Access Compliance Report

Public Rights-of-Way

Intersection ID: 15131	Main Street: FILLMORE_AV	Cross Street: SCOTT_AV	Location: N
ADA ID: E4A42190E9EF	Ramp Type: Perp	Initial Pass/Fail: Fail	Overall Compliance: No
Severity Score: 13.75			
Codes/Mitigation Info/Possible Solution		Field Measurements/Component Compliance

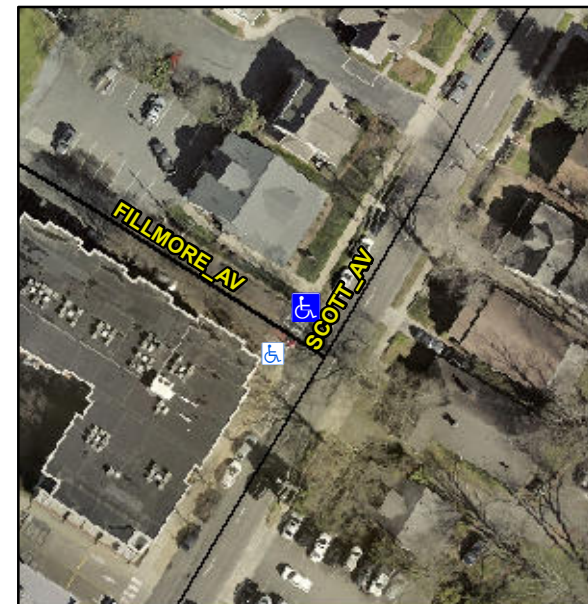
Not Found, R304.2.2, R304.5.3

Compliance	Description	Data	Compliance	Description	Data
N/A	Ramp Length (in)	66.0	No	Ramp Slope (%)	10.7
Yes	Ramp Width (in)	57.0	No	Ramp XSlope (%)	4.4
N/A	Flare Type LT	N/A	N/A	Flare Type RT	N/A
N/A	Flare Slope LT (%)	N/A	N/A	Flare Slope RT (%)	N/A
N/A	Flare Traversable LT?	N/A	N/A	Flare Traversable RT?	N/A
N/A	Landing Length (in)	N/A	N/A	DWS Provided?	N/A
N/A	Landing Width (in)	N/A	N/A	DWS Contrast?	N/A
N/A	Landing Slope (%)	N/A	N/A	DWS Length (in)	N/A
N/A	Landing X Slope (%)	N/A	N/A	DWS Full Width?	N/A
N/A	Landing Curb? (Y/N)	N/A	N/A	DWS Offset (in)	N/A
N/A	Shared Landing?	N/A			
N/A	Gutter Ponding?	Yes	N/A	Gutter Slope (%)	N/A
N/A	Gutter Lip Ht (in)	N/A	N/A	Gutter X Slope (%)	N/A
N/A	Painted X Walk1?	Yes	N/A	Painted X Walk2?	N/A
	X Walk 1 Direction	To SW		X Walk 2 Direction	N/A
N/A	X Walk 1 Width (in)	112.0	N/A	X Walk 2 Width (in)	N/A
	X Walk 1 Slope (%)	0.2		X Walk 2 Slope (%)	N/A
	X Walk 1 X Slope (%)	4.3		X Walk 2 X Slope (%)	N/A

Remove & Replace Entire Ramp.
